Re: Remedial Action Work Plan Addendum #2  
Site Remediation File No. SR-26-0934A/Formerly RIDEM Case No. 95-022  
Former Tidewater Facility  
200 Taft Street  
Pawtucket, Rhode Island

GZA GeoEnvironmental, Inc. (GZA), on behalf of The Narragansett Electric Company d/b/a National Grid (National Grid), has prepared this second addendum to the June 2018 *Remedial Action Work Plan* (RAWP) for the Former Tidewater Facility located in Pawtucket, Rhode Island (herein referred to as the Site). This second addendum outlines certain proposed modifications to the remedy included in the June 2018 RAWP and the May 2019 RAWP Addendum for approval by the Rhode Island Department of Environmental Management (RIDEM). These remedy modifications are due to the development of the northern portion of the Site as a stadium facility by Fortuitous Partners under a long-term lease agreement with National Grid and the realignment of the existing combined sewer outfall (CSO) at the Site by the Narragansett Bay Commission (NBC).

CHECKED BY:	DJR	SCALE:	AS SHOWN
REVISION NO.:		DRAWING	1
		SHEET NO.	1 OF 4

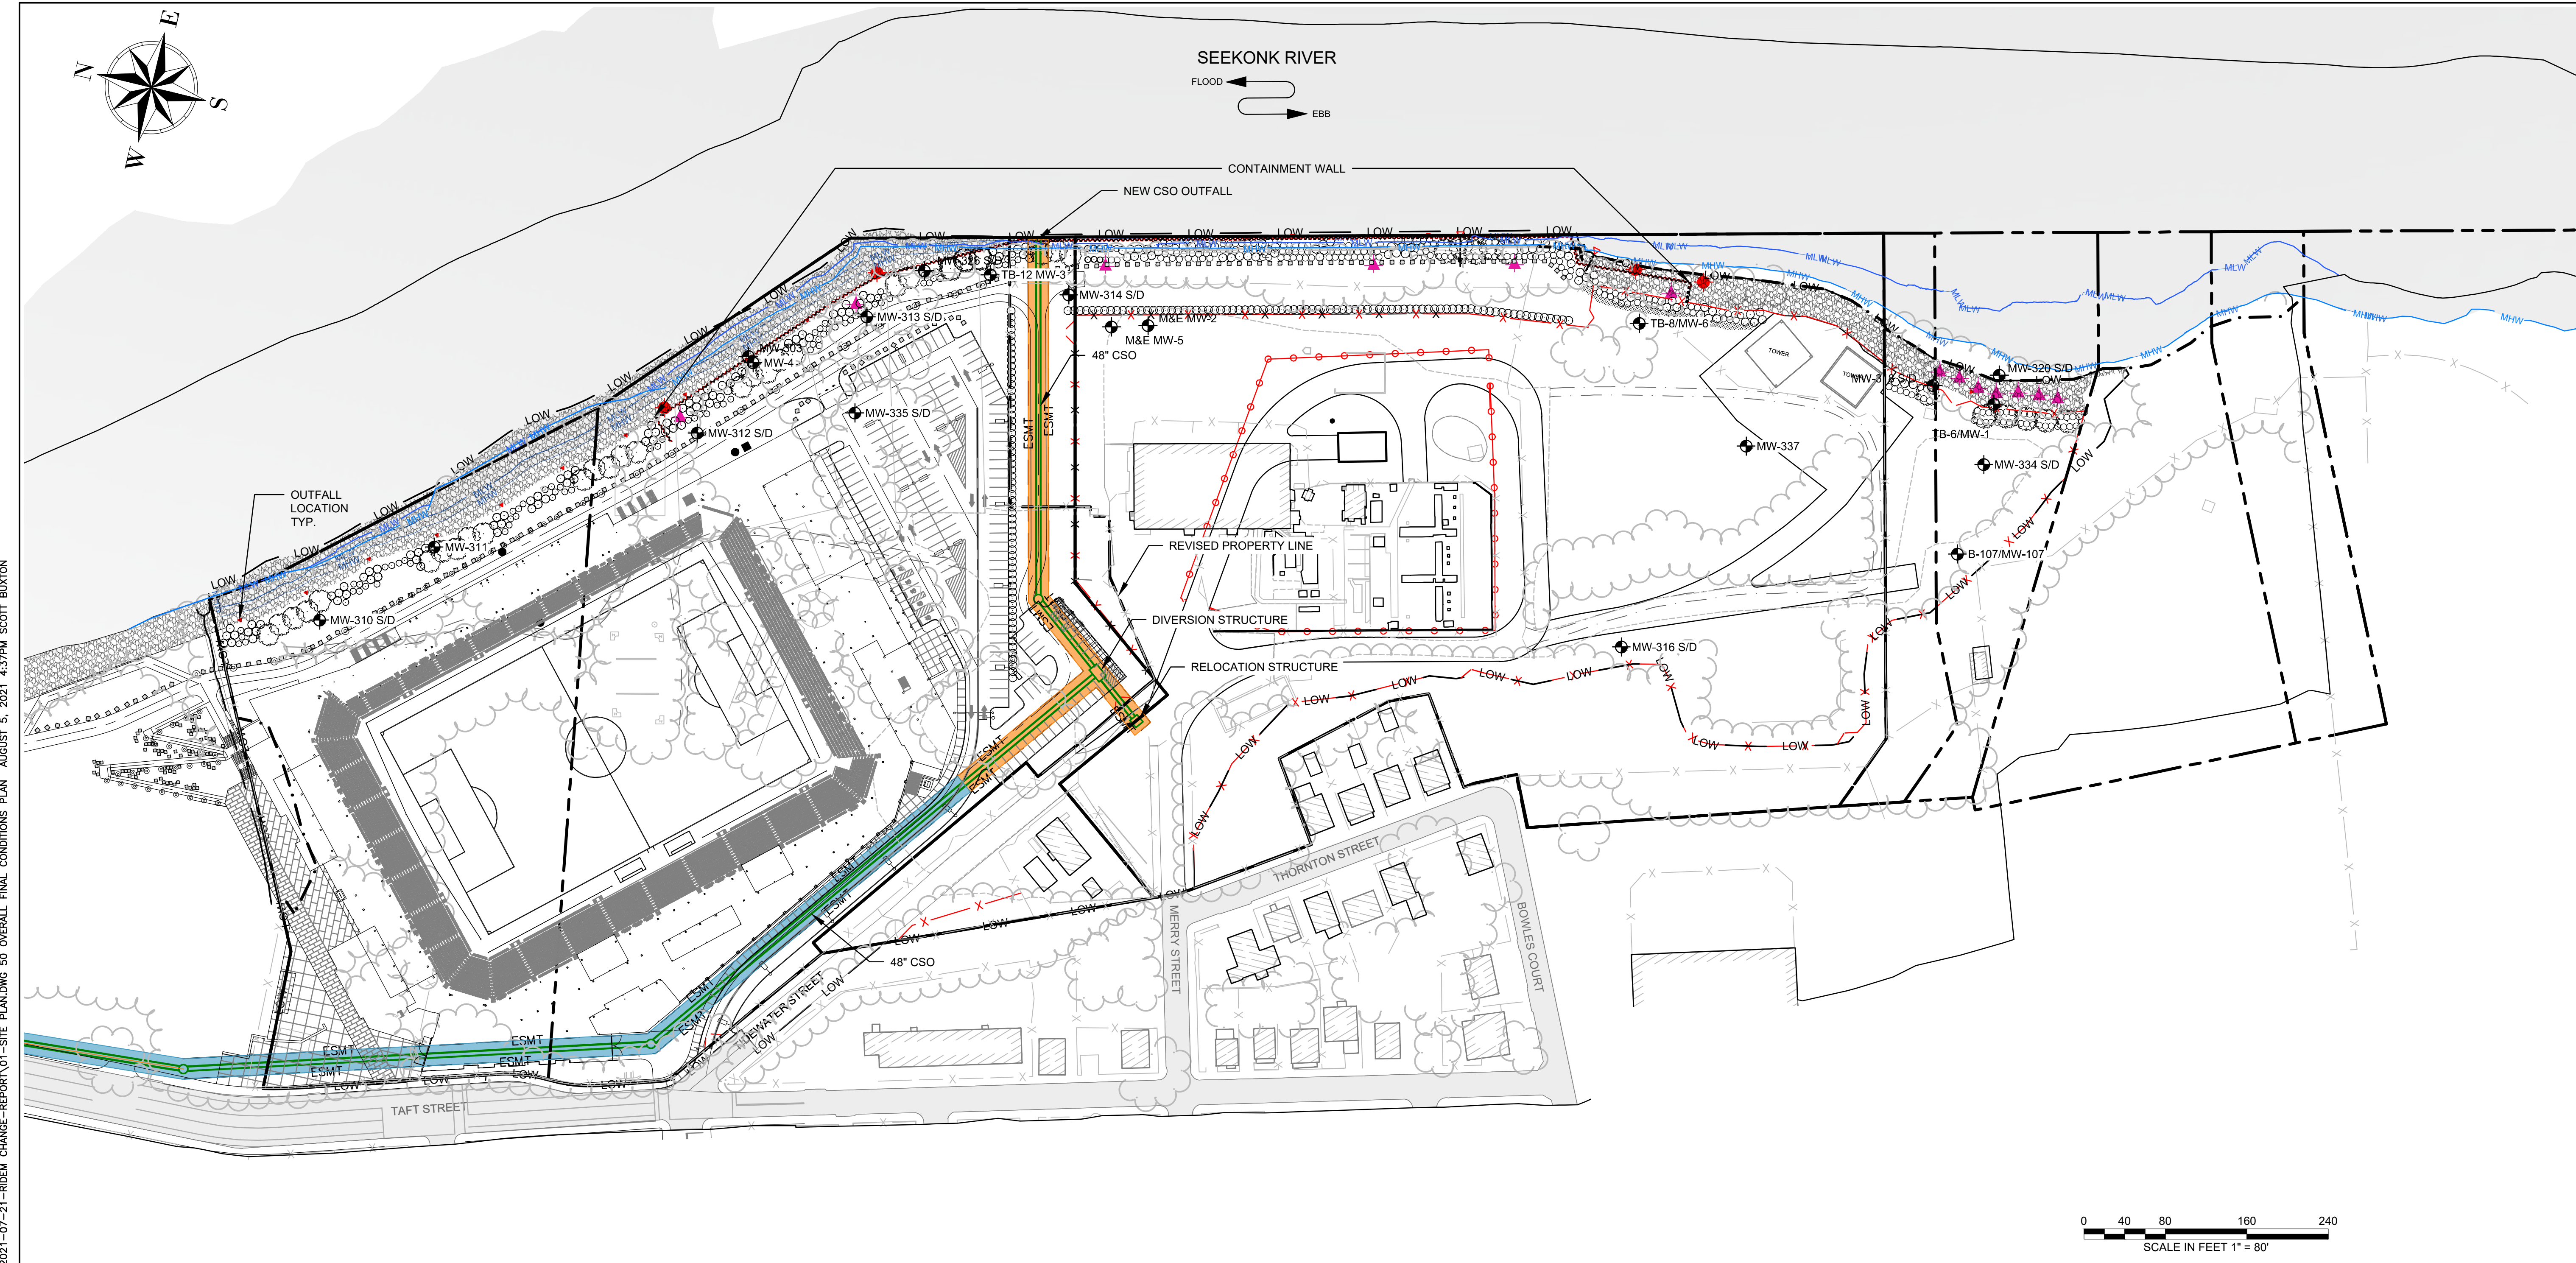
A Site Plan depicting the layout of the stadium is attached as **Drawing 1**.

A Site Plan depicting the layout of the realigned CSO pipe is attached as **Drawing 1**.

**REVISED CAPPING PLAN**

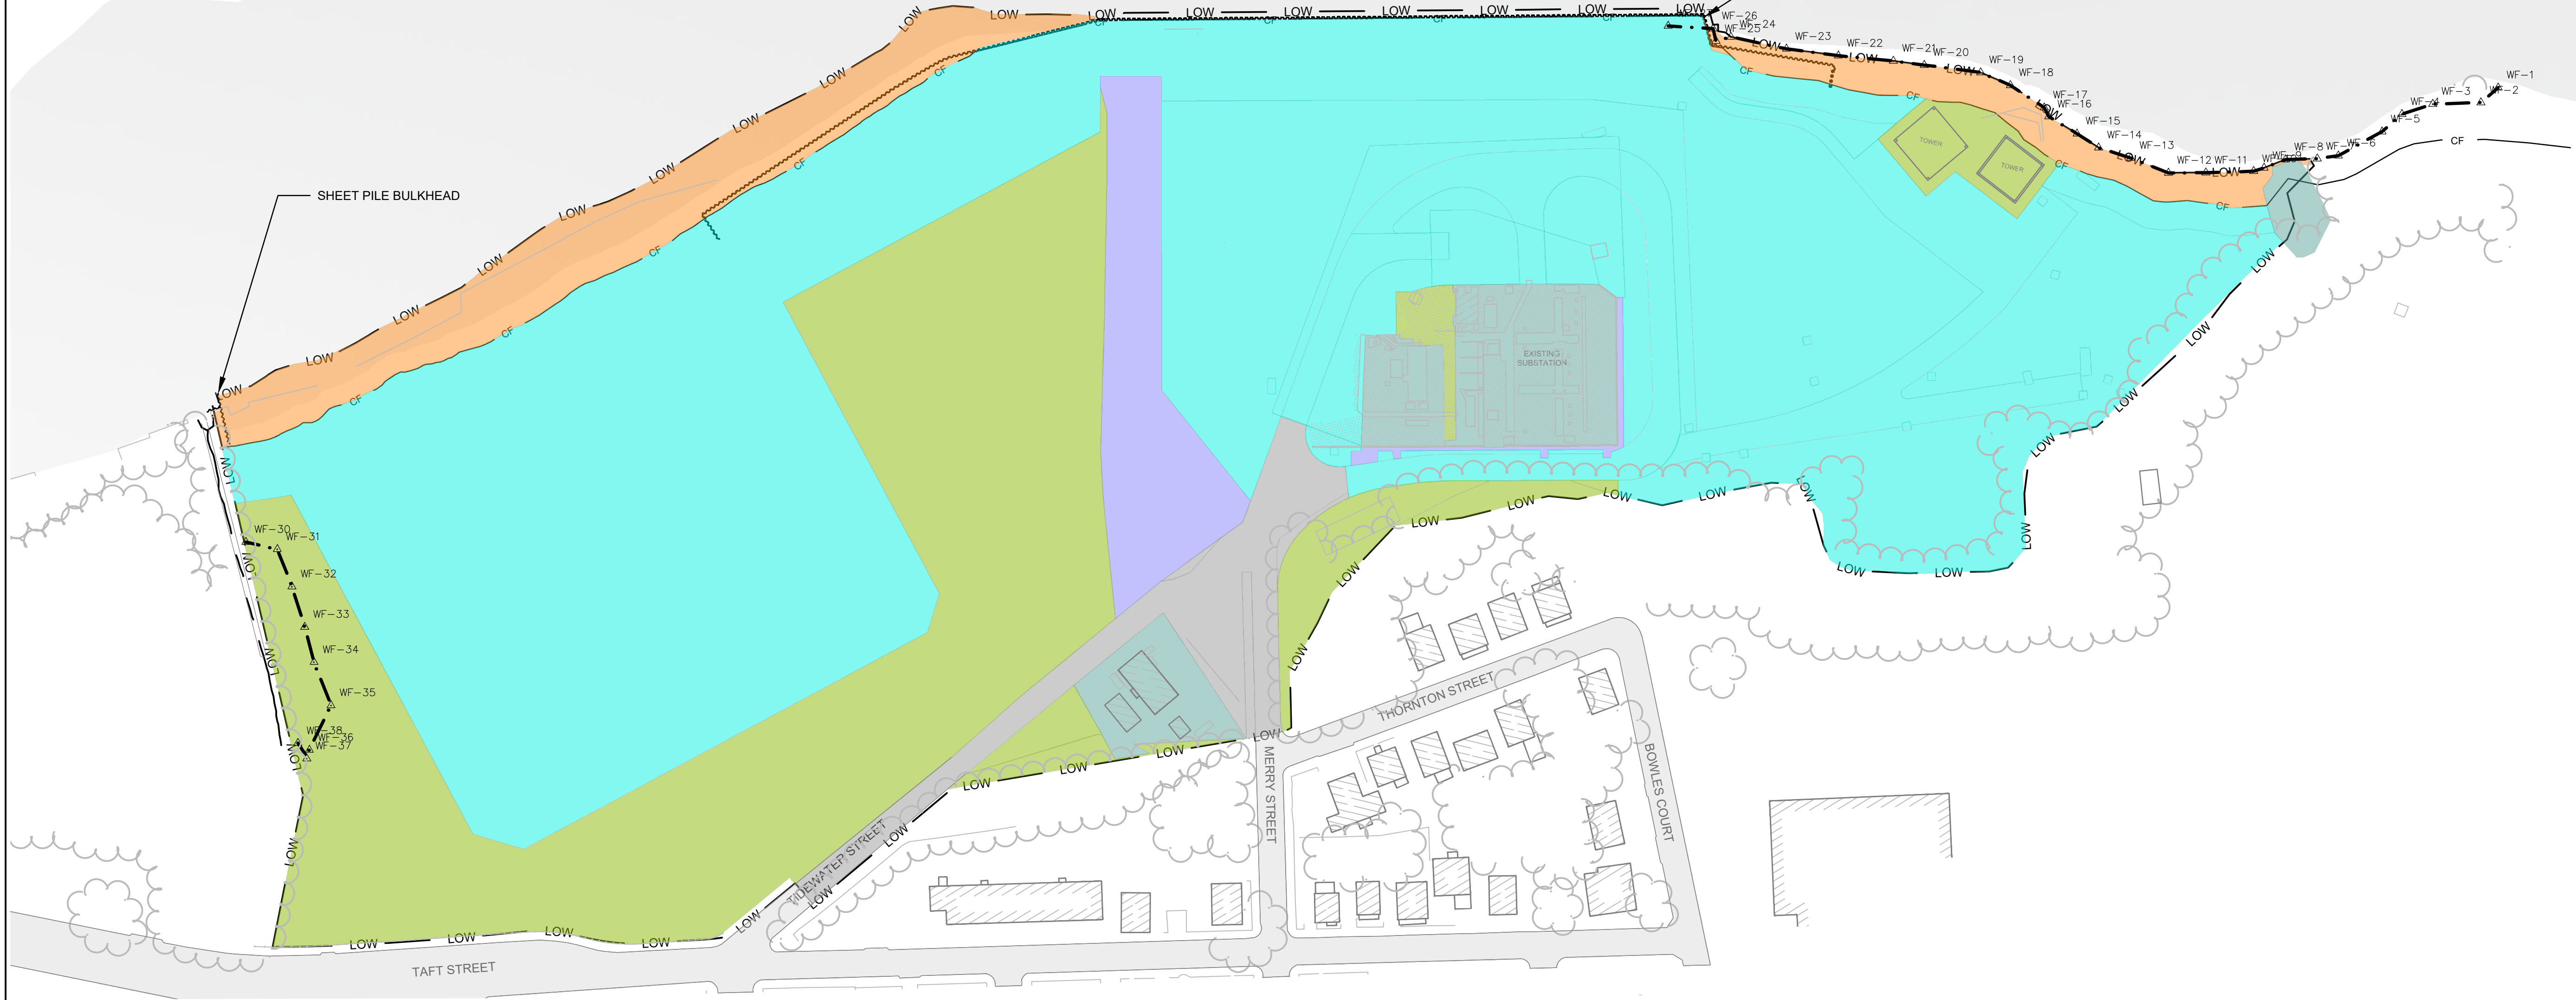
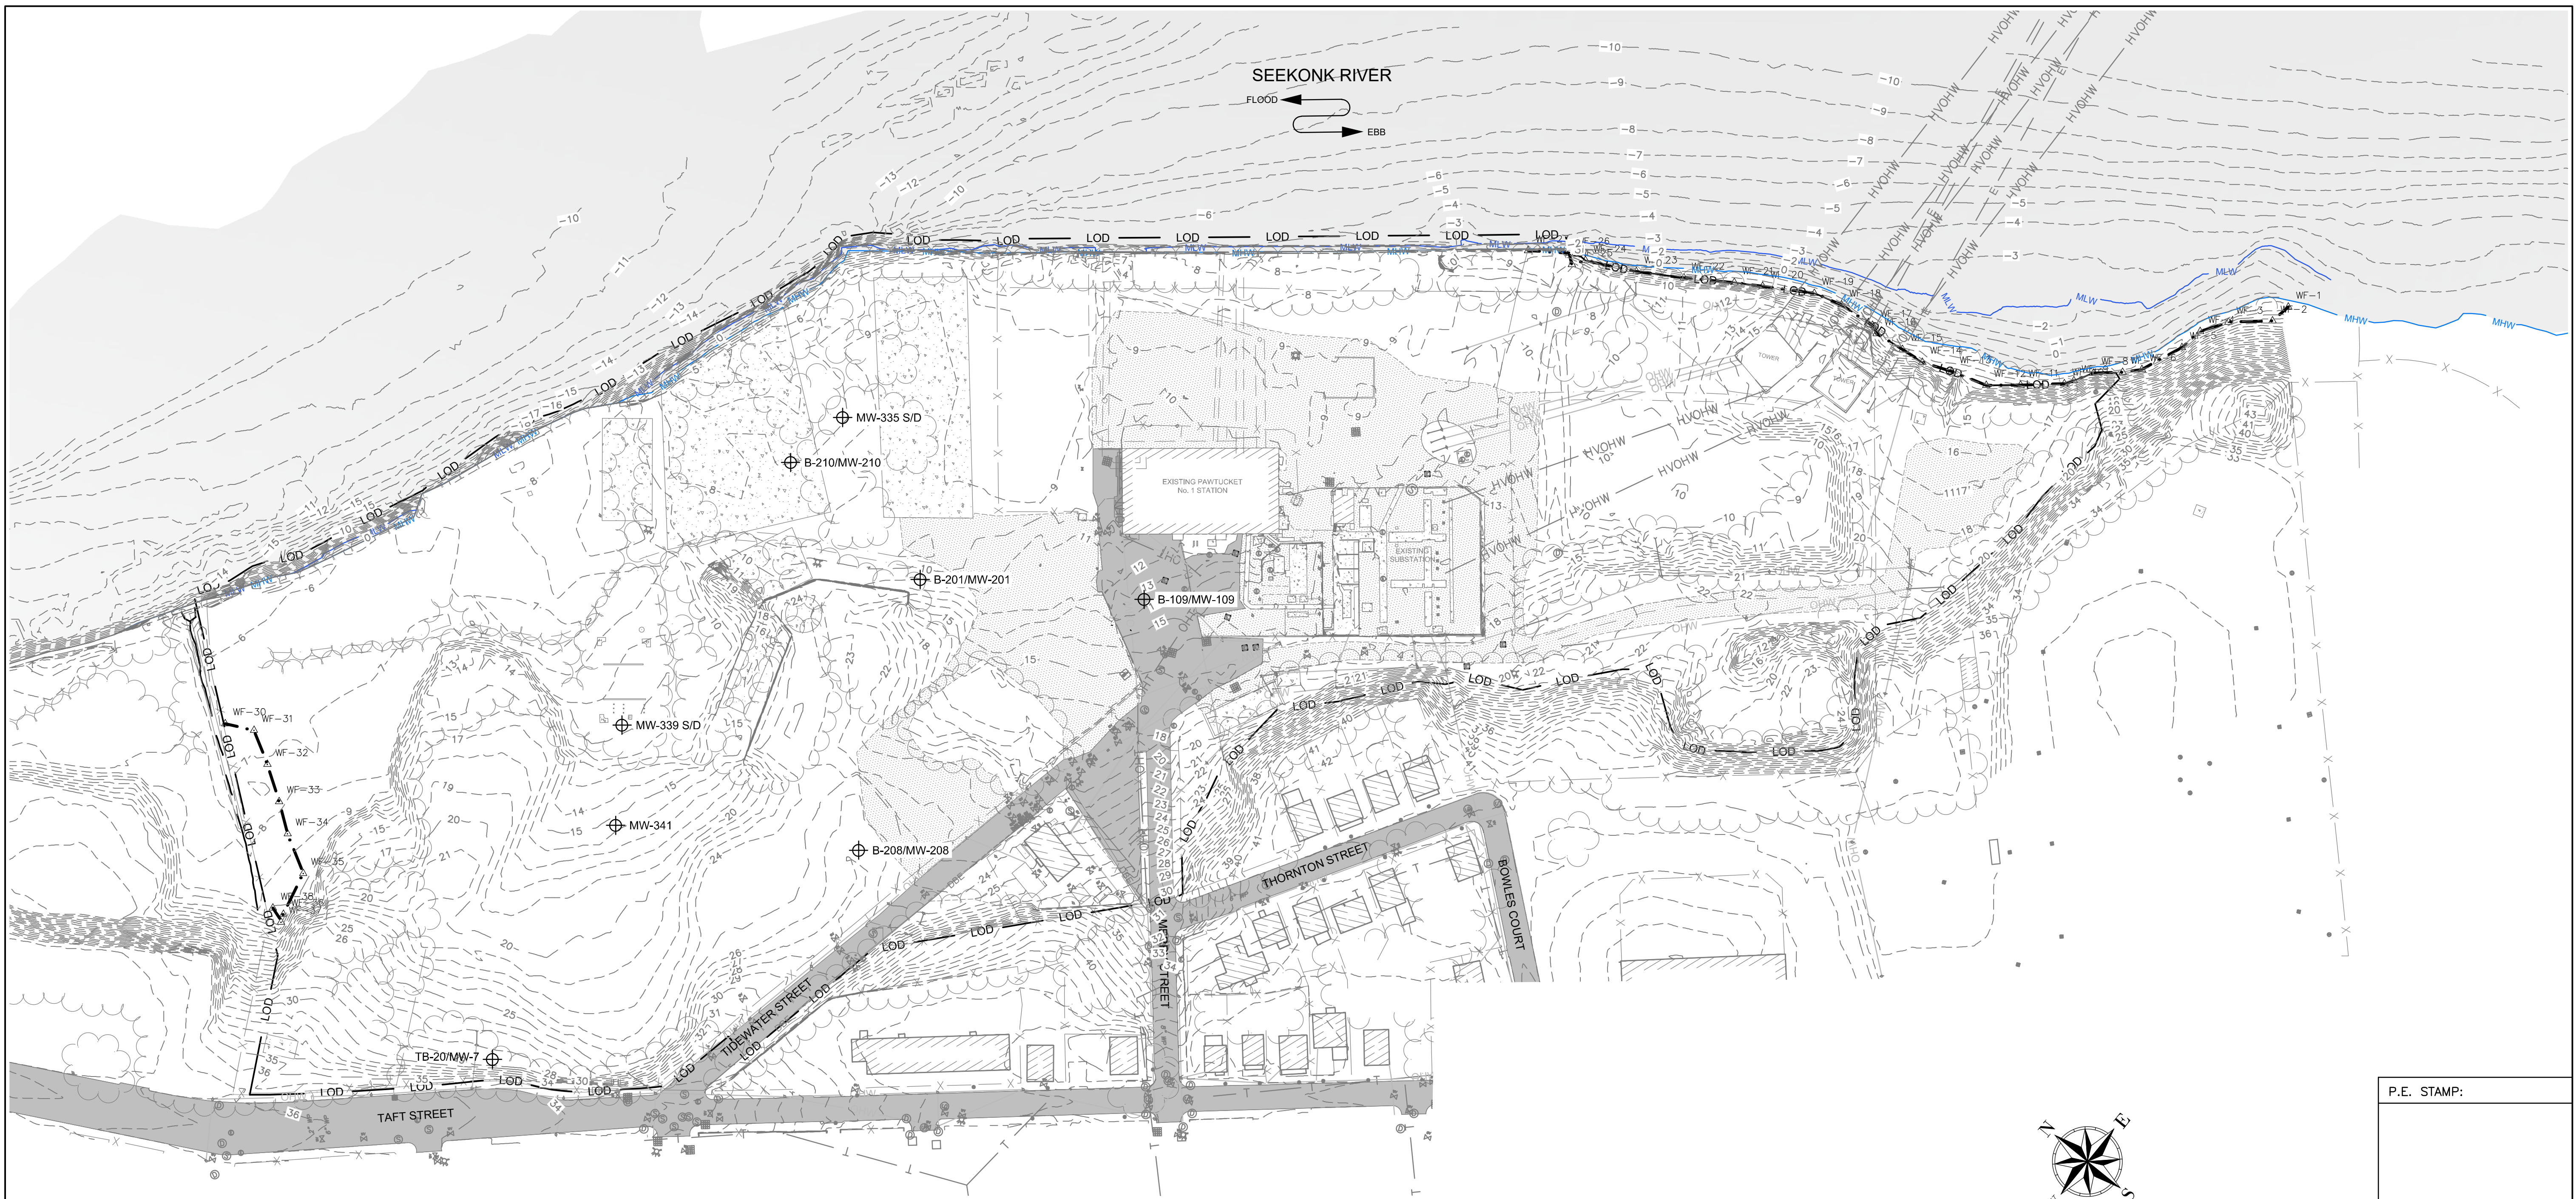
- The impermeable cap will be installed beneath the eastern portions of the FGPA and NFA and beneath the stadium field and bleachers as depicted on attached **Drawing 2**. The impermeable cap will consist of a 50-mil linear low-density polyethylene (LLDPE) liner underlying at least 24-inches of imported clean fill, which is the same material as previously approved.

- In the areas to the north, west, and south of the bleachers where hardscaped/paved areas or buildings will be constructed, the engineered cap will consist of a non-woven geotextile fabric to act as a warning barrier underlying at least 12-inches of clean imported fill. The extent of the geotextile engineered cap is depicted on attached **Drawing 2**. We note that additional clean imported fill will be placed by the developer to achieve final design grades so the actual clean engineered cap thicknesses will be greater than 12-inches in thickness. In addition, a vapor barrier will also be installed beneath the footprint of the buildings to mitigate the potential for vapor intrusion into the occupied spaces.

- In the vicinity of the new CSO pipe approximately where the pipe will be installed via open excavation methodology, the engineered cap will consist of a non-woven geotextile fabric to act as a warning barrier underlying a 6-inch-thick layer of relatively impermeable clay underlying an 18-inch-thick layer of imported clean fill. The extent of the geotextile low permeability engineered cap is depicted on attached **Drawing 2**.
